**Central Zoo Authority**

F. No. 19-32/93-CZA(95)(Vol. III)(M) | 3852 DATE: 18.11.2013

**Sub:- Power point presentation for the construction of new Pheasantry for Western tragopan at Sarahan.**

TYPICAL PLAN OF AVIARY

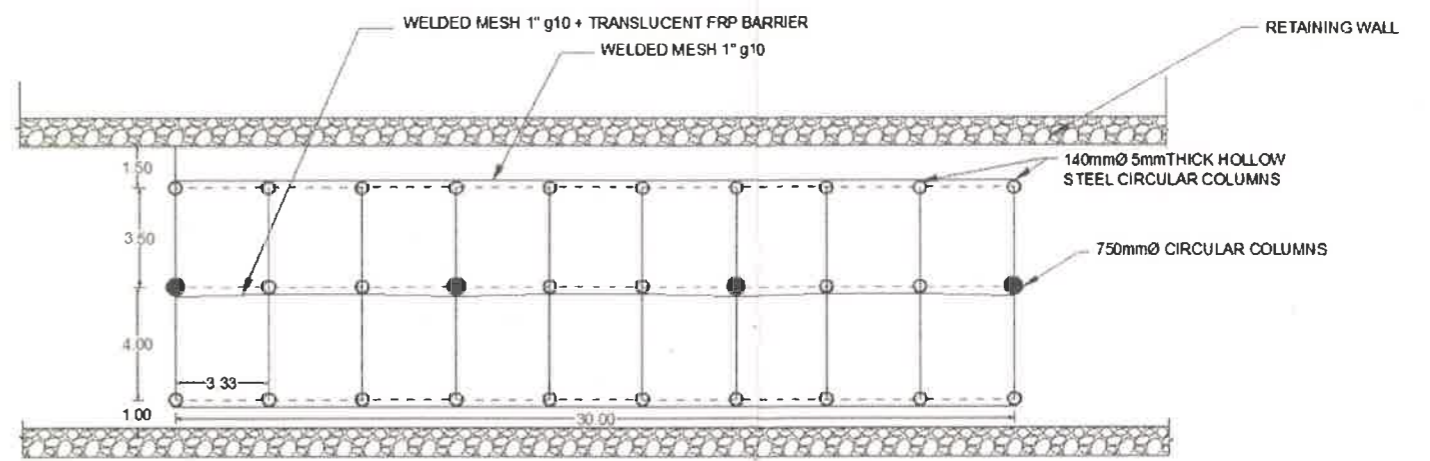
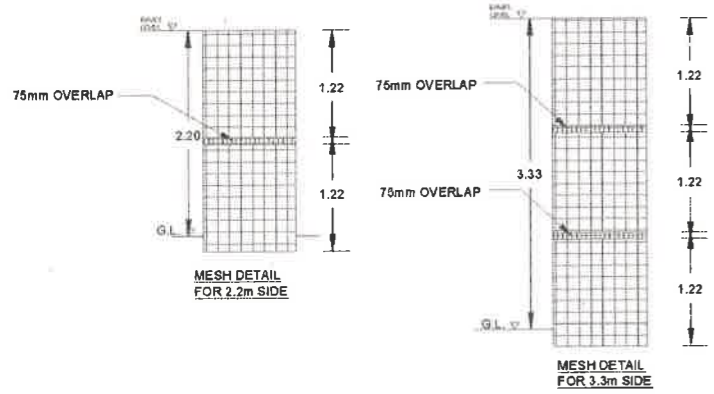
- Keeper entry door should be of 2mt high and the width should be kept 1mt.
- Inter connecting gate should be located in such a way that it does not hinder the transportation of logs etc. as an enrichment to the aviary.
- Slop of the aviary should be increased substantially so that it will not retain snow.
- Retaining wall provided on the sides should be round so that snow falling from sides may be arrested rather falling down and to prevent damage of lower wall/ enclosure. The parapet wall of 1mt. should be provided in order to prevent damage to chain-link fence.
- The entire aviary should be made rodent proof.

- f) The door of the indoor enclosure should be smaller in dimension with the every house should open in a small keeper gallery attached to the indoor house.
- g) There should be sufficient enrichment inside the aviaries including dust bath and water trough.
- h) The covered portion of the breeding area should protrude out of the indoor house.
